Comment (Comment r02-119, r02-70 clause 145.4.1 page 217 line 39)

Annex A – PSE – PD configurations for specifying isolation.

Figure 1: Dual-signature, single load PD.

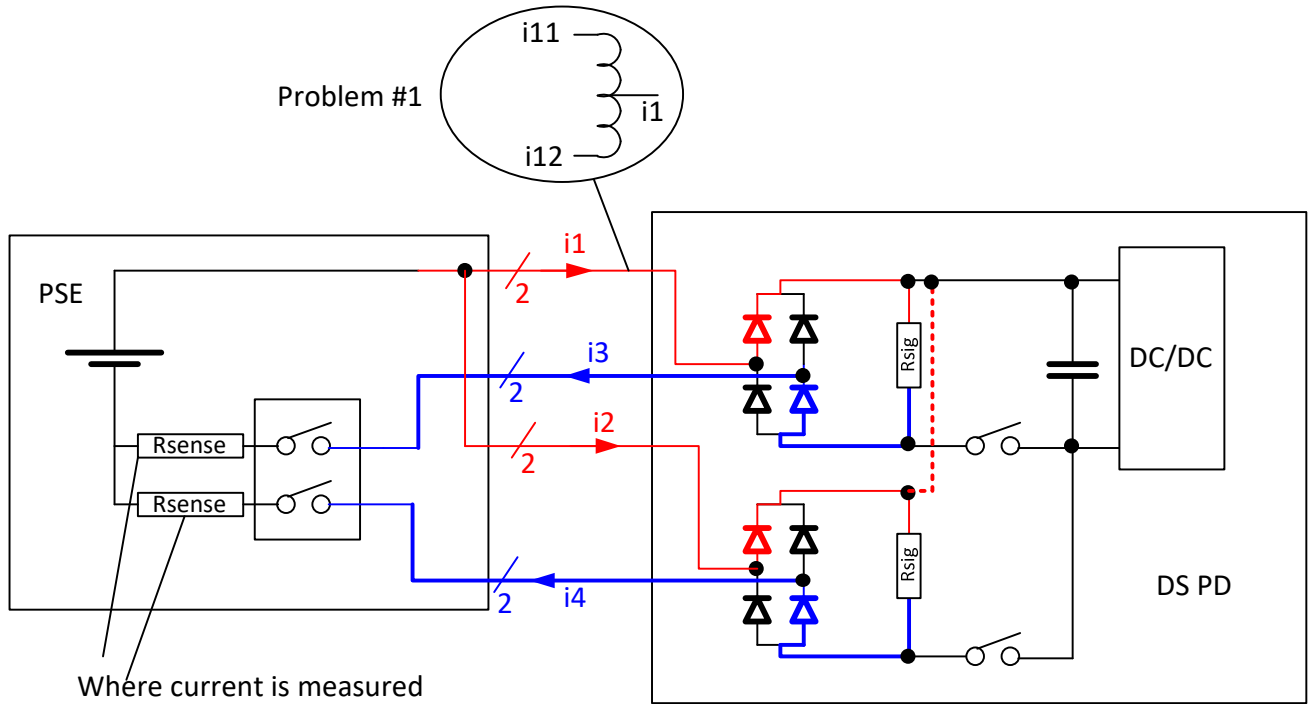
Figure 1:

- Switching on the negative is mandatory
- Measuring current on the negative when switching on the negative is the only practical choice since measuring on the positive will result with pairs currents that are not correlated to the negative pairs currents due to unbalance.
- As a result, it is guaranteed only in the negative pairs, that PSE will support PD successfully when measuring the pair current for connection check, detection and classification circuits in dual-signature PDs.
- In addition, the positive side is tied together at the PSE side which effectively, tied the positive pairs at the PD side as well.

Figure 2: Dual-signature, dual load PD.

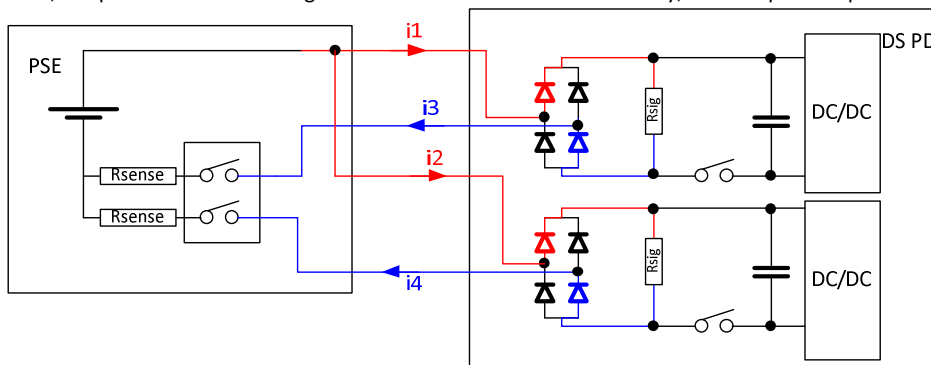
Figure 2:

By definition, the positive pairs and negative pairs are isolated in the PD primary side (secondary may have common GND and typically this is the case). However, since as in the previous case the PSE is required to support switching on the negative pairs, PD is not guaranteed to be supported on the positive pairs making the isolation requirements on the PD positive pairs with no value.
